The River Cooum.

Referring to the Sanitary Engineer, for remarks, Chief Engineer's note on the scheme for the improvement of—, and requesting him to specify, in detail, how far the amendments suggested by the Chief Engineer will affect the estimates already submitted.

NOTE by the Chief Engineer, Public Works Department, on G.O., dated 11th March 1891, No. 349 M.

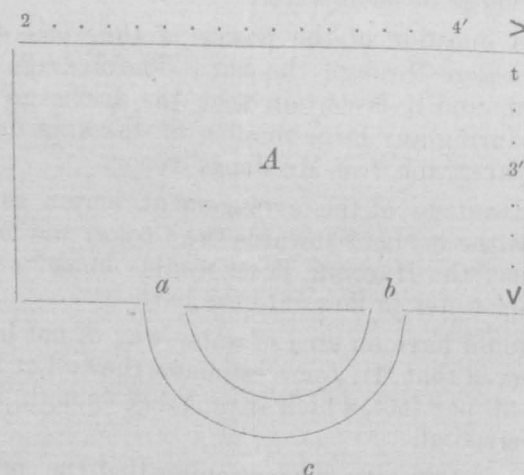
13. Admission of tidal water, and its emission by the same outlet, will produce oscillation, but not, or only to a very trifling extent, circulation. A very simple experiment will show this:—

A is a good-sized tank 12 inches deep and  $abc$  a curved trough of the same depth connected with the tank at both ends. If the tank be filled to within about six inches of the top and some light material such as sawdust sprinkled over the surface of the water in  $abc$ , and the tank then alternately filled to the brim and emptied to six inches from it, it will be found that there is next to no movement of the sawdust, and this will be the case whether both ends  $a$   $b$  be kept open or one closed and the water admitted through the other; showing that there is nothing like real circulation in the trough  $abc$ .

15. If instead of keeping one or both ends of the trough permanently open, we now close the end  $b$  while the tank is being filled, and while it is being emptied close both ends until the water has fallen three inches and then open  $b$ , it will be found that a decided current is produced from  $a$  towards  $b$  and that after a few "tides," the whole of the floating sawdust will have been carried out through  $b$  into the tank.

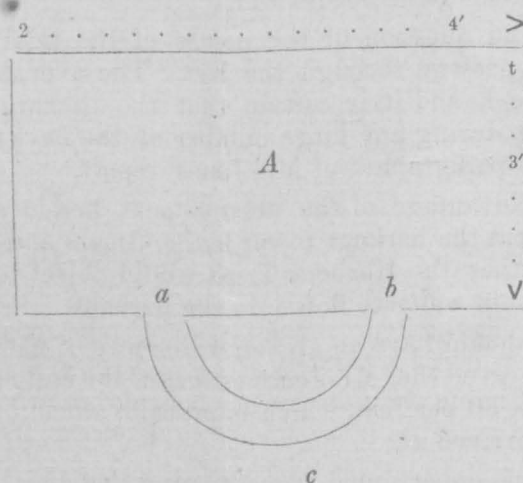
13. Admission of tidal water, and its emission by the same outlet, will produce oscillation, but not, or only to a very trifling extent, circulation. A very simple experiment will show this:—

A is a good-sized tank 12 inches deep and  $a b c$  a curved trough of the same depth connected with the tank at both ends. If the tank be filled to within about six inches of the top and some light material such as sawdust sprinkled over the surface of the water in  $a b c$ , and the tank then alternately filled to the brim and emptied to six inches from it, it will be found that there is next to no movement of the sawdust, and this will be the case whether both ends  $a b$  be kept open or one closed and the water admitted through the other; showing that there is nothing like real circulation in the trough  $a b c$ .

15. If instead of keeping one or both ends of the trough permanently open, we now close the end  $b$  while the tank is being filled, and while it is being emptied close both ends until the water has fallen three inches and then open  $b$ , it will be found that a decided current is produced from  $a$  towards  $b$  and that after a few "tides," the whole of the floating sawdust will have been carried out through  $b$  into the tank.

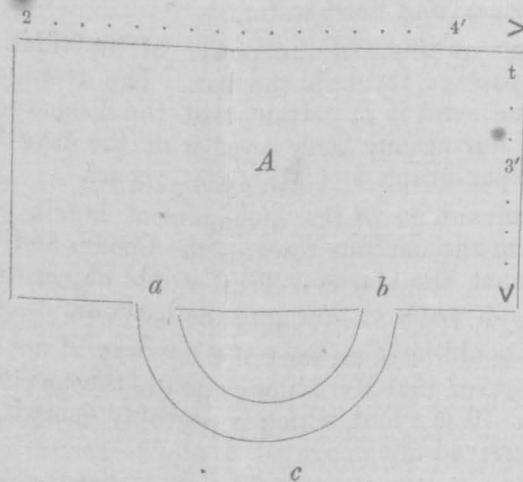
13. Admission of tidal water, and its emission by the same outlet, will produce oscillation, but not, or only to a very trifling extent, circulation. A very simple experiment will show this:—
